The ISO received comments on the topics discussed at the February 8, 2018 stakeholder call from the following:

The following are the ISO's responses to the comments.

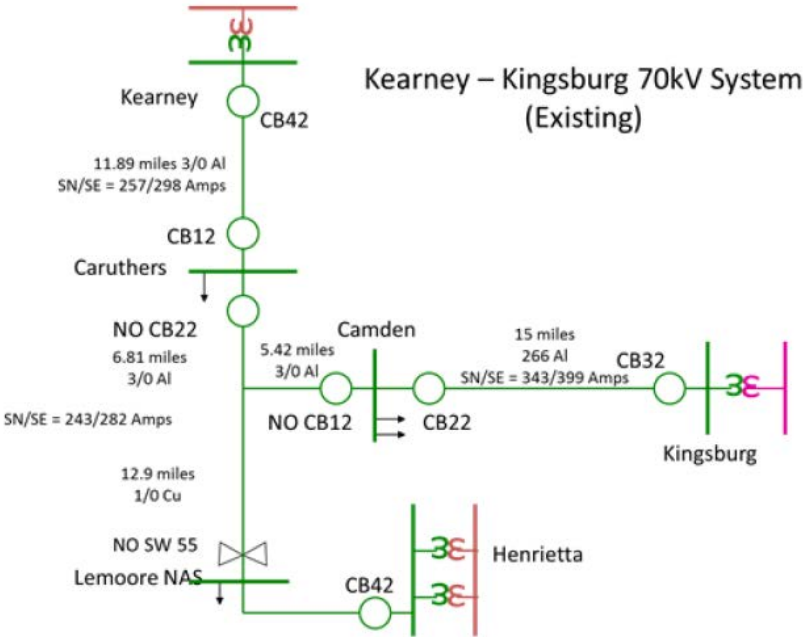
<p>4. ORA Supports Putting the Midway-Andrew Project on Hold or Cancelling it</p> <p>The Midway-Andrew Project is among the six projects that the CAISO recommends putting on hold in the Northern area of the CAISO-controlled grid. As stated in ORA’s November 30, 2017 comments on the Midway-Andrew Project, ORA generally supports further analyses of the Midway-Andrew project to determine if it is still necessary. This analysis should consider the existing transmission lines in the project area and their ability to solve reliability issues that may still exist after the retirement of the Diablo Canyon Power Plant. As noted, there are a number of 500 kV lines and 230 kV lines in the Diablo Canyon-Midway-Andrew project area that may be under-utilized or experience lower demand after the retirement of the Diablo Canyon Power Plant.</p> <p>ORA recommends that any additional presentations on this project and its analysis include the current cost estimates and Benefit Cost Ratio (BCR) calculations for the project and the proposed alternatives. ORA is making this request because the Midway-Andrew project costs have increased since presented in 2012. To illustrate, Pacific Gas and Electric Company’s (PG&E) original cost estimate for the Midway-Andrew project from the 2012-2013 TPP was \$120 to \$150 million. The project cost estimate in a 2016 FERC filing and in 2017 PG&E Assembly Bill (AB) 970 reports ranges from \$215 million to \$414 million and up to \$700 million. This broad range of cost estimates makes it difficult to assess the value of removing the existing Special Protection System</p>	<p>The ISO will continue the assessment of alternatives of the Midway-Andrew project in the upcoming planning cycle.</p>

No	Comment Submitted	CAISO Response
	<p>from the project area and proceeding with the Midway- Andrew project as proposed.</p> <p>While the Midway-Andrew project is on hold, ORA recommends that PG&E not conduct any engineering design or environmental studies to support this project to avoid accruing any unnecessary costs for a project that may later be cancelled.</p>	
	<p>5. ORA Recommends Canceling The Gates-Gregg 230 kV Line Project The Gates-Gregg 230 kV line project is also among the six projects that CAISO recommends be put on hold in the Northern area of the CAISO controlled grid.¹⁷ As stated in ORA's November 30, 2017 comments on the CAISO 2017-2018 TPP, ORA recommends canceling the Gates-Gregg project as soon as possible to avoid incurring any unnecessary carrying costs. The cost of this project has increased significantly since approved in the 2012-2013 TPP from \$145 million¹⁸ to \$200 million in 2017.¹⁹ With this cost increase, the BCR threshold for this project may no longer be met. ORA recommends that future presentations on this project and other projects under evaluation include the BCR calculations to confirm the value of presented projects as updated information becomes available.</p>	<p>The ISO will continue to assess the need and benefits of the Gates-Gregg project in the upcoming planning cycle.</p>
